Hornsea Project Three Offshore Wind Farm

Applicant's Response to Highways England Briefing Note 01A

Date: November 2018

Figure 2.1 – Crashmap A47/Taverham Road Junction Assessment

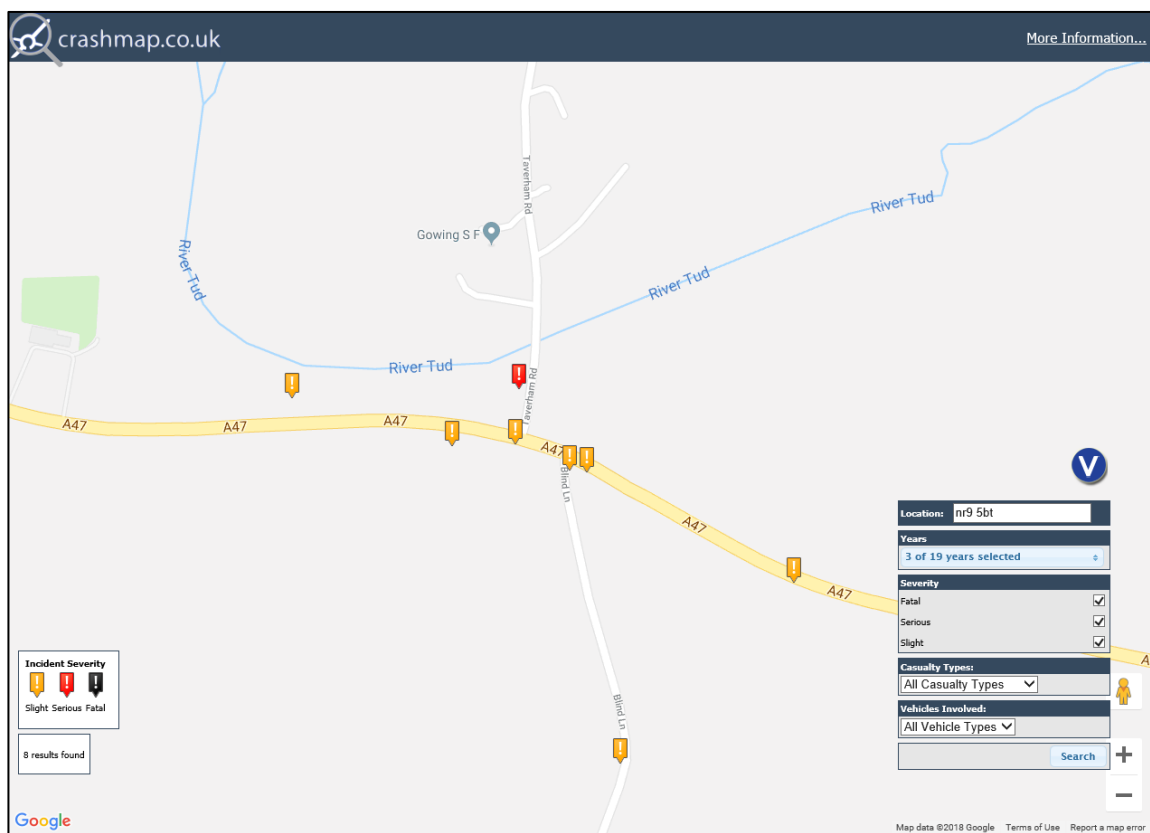
- 2.19 It is noted that there are currently some issues with overrunning on the minor arm of the A47/Taverham Road junction, however, the track run analysis indicates that the required Hornsea Three HGV movements would be contained within the existing kerb lines. The existing overrunning appears to be principally associated with existing agricultural vehicles. This junction would, however, be included within the overall Construction Traffic Management Plan for the Hornsea Three scheme and should there be significantly increased wear and tear at this junction that can be directly associated with the scheme, then remedial action can be taken accordingly.

- 2.20 To address the AECOM concerns regarding the A47/Taverham Road junction a review of road safety has been carried out using the "Crashmap" recorded personal injury accident database. The review includes three years of accident data to the end of 2017 as shown in Figure 2.1 below:

- 2.21 The Crashmap data depicted in Figure 2.1 shows that only one accident occurred on the A47 immediately adjacent to the Taverham Road junction. This accident is classified as 'Slight' in severity and was recorded on the 15 January 2016 involving two vehicles resulting in one casualty.
- 2.22 Figure 2.1 also shows an accident recorded on Taverham Road approximately 35m north of the junction with the A47. This accident occurred on 26 July 2017 and is classified as 'Serious' in severity involving two vehicles and one casualty.
- 2.23 The next closest accident to the A47/Taverham Road junction was recorded on 4 May 2018, approximately 50m to the west on the A47. This incident was classified as 'Slight' in severity involving two vehicles and two casualties.

- 2.24 The two accidents shown to the east of Taverham Road along the A47 are more closely linked to the Blind Lane junction to the south and therefore are not relevant to this assessment.

- 2.26 Consequently, it can be asserted that there are no prevailing accident issues associated with the A47/Taverham Road junction arrangement and this is likely to remain so with the introduction of Hornsea Three.
